17SUBDIV1025

Aiken II

Louisville Metro Planning Commission Public Hearing

March 1, 2018

VARIANCE EXHIBIT
AIKEN II-CONSERVATION SUBDIVISION
 CASE #17SUBDIV1025

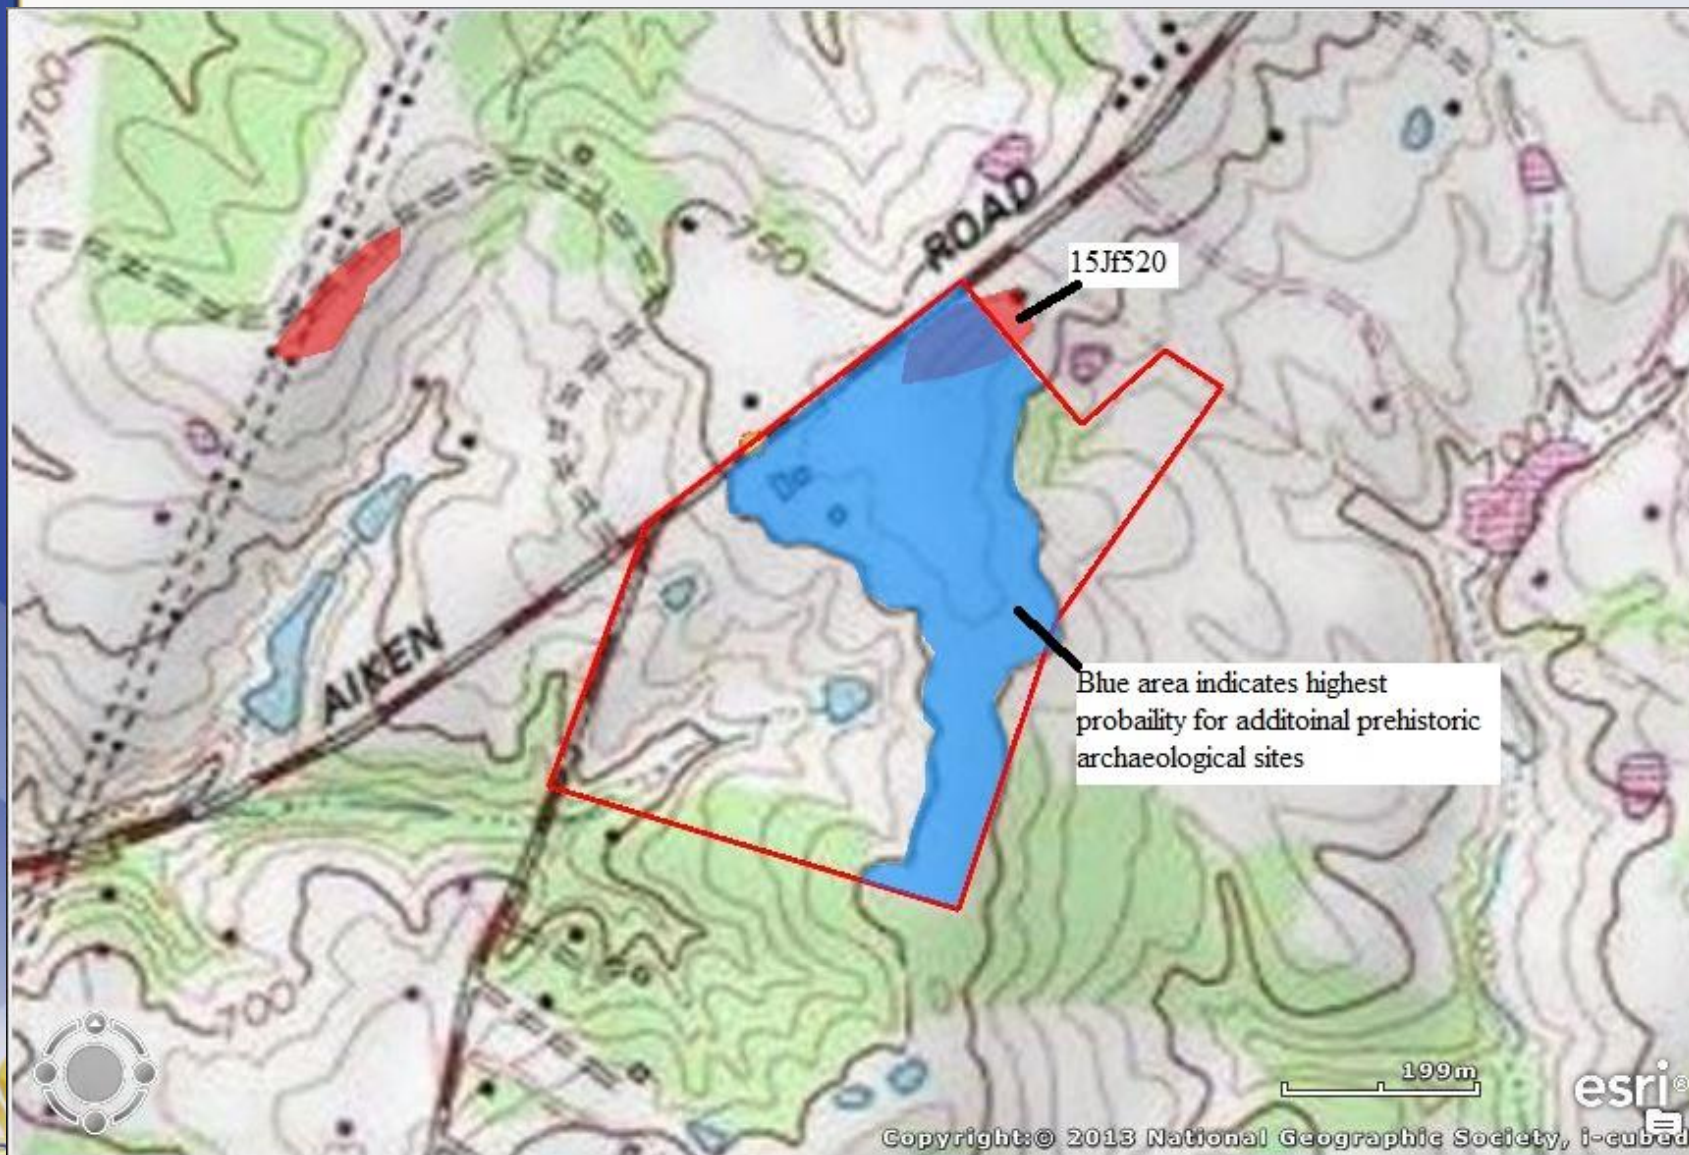
1. A VARIANCE IS REQUESTED OF 7.11.10.C OF THE LDC DIMENSIONAL STANDARDS TO INCREASE THE MAXIMUM FRONT YARD FROM 25' TO 40'.
2. A VARIANCE IS REQUESTED OF 7.11.10.C OF THE LDC DIMENSIONAL STANDARDS TO DECREASE THE MINIMUM SIDE YARD FROM 3' TO 0' ALONG ONE SIDE OF EACH RESIDENTIAL LOT.

- Conservation Subdivision generally meets the requirements of the Land Development Code, specifically those under Section 7.11
- Variances appear justified due to consistency of design meeting the intent of the Conservation Subdivision regulations
